CRoW Act 2000: Natural Resources Wales application for permission - Formal Notice

Natural Resources Wales Formal Notice.

1. Natural Resources Wales area/region/NPS hub:	South Central
2. Name of SSSI:	Severn Estuary (Wales) SSSI (33WGX) : Located 88-320 meters from the proposed activities Gwent Levels - Rumney and Peterstone (33WET) : approximately 1500 meters to the east of the installation
3. Type of permission:	Environmental Permit
4. Date for Natural Resources Wales permit determination:	09/02/2024 (draft decision)
5. Predicted 28 day date for response from NRW conservation/ecology (under S28 I(4)):	N/A Filed for audit
6. Natural Resources Wales reference no:	EPR/TP3639BH/V010 (PAN-018725)
7. National grid reference:	ST 21508 76337 (Shredder Yard)

Celsa Manufacturing UK Limited have applied to vary their installation permit (EPR/TP3639BH) for Tremorfa melt shop, which includes the Rover Way site, primarily for the addition of a new shredder that will process more than 75 tonnes per day and falls under Schedule 1 activity, Section 5.4 Part A(1) b iv of the Environmental Permitting Regulation (EPR) 2016. The site will also have the following changes:

Figure 1: Map showing risk screening distance and location of SSSI

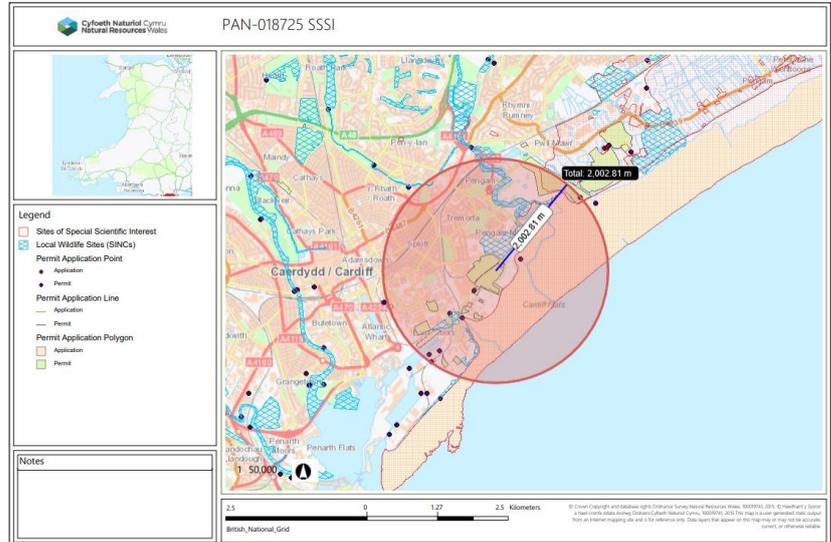
Severn Estuary SSSI- The installation boundary is adjacent to the SSSI boundary but location of the proposed activities are 320 meters from new shredder and 88 meters from new location of slag handling equipment

Gwent Levels - Rumney and Peterstone approximately 1580 meters from the installation

Figure 2: Isopleth of predicted ground level concentration of Particulate matter (10 µm diameter) taken from the air quality impact assessment (Prepared for Earth & Marine Environmental Consultants Ltd By ADM Ltd) copy available on the online public register.

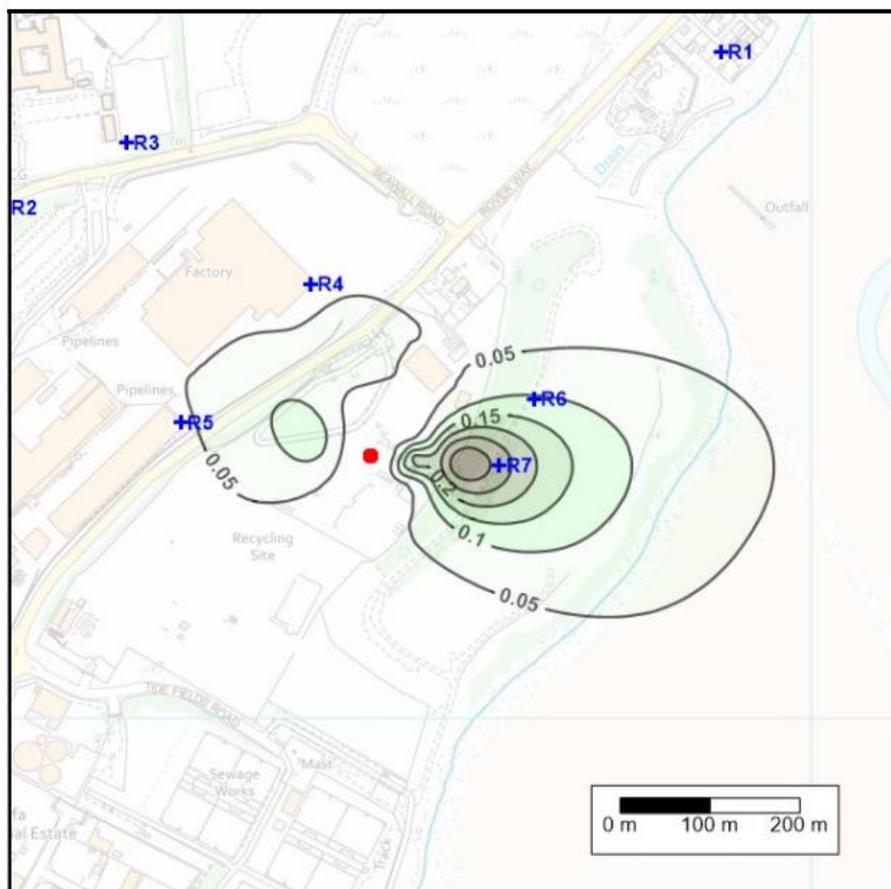
While particulate matter does not have an ecological standard the applicant had shown in their submitted air impact assessment that the concentration at worst case scenarios would be less than $0.05 \mu\text{g/m}^3$ for annual average at the closet point between the point source emission and the designated site. The isopleth produced by the applicant shows that the emission of particulate matter rapidly decreases within a relatively short distance (100-200 meters) therefore the worst case scenario (which is almost negligible) would only occur within a small area of the SSSI.

Given the very small amount of deposition presented for worst case scenario in a small area of the SSSI, the emissions of dust from the shredder are unlikely to lead to any real damage to the features of the SSSI.
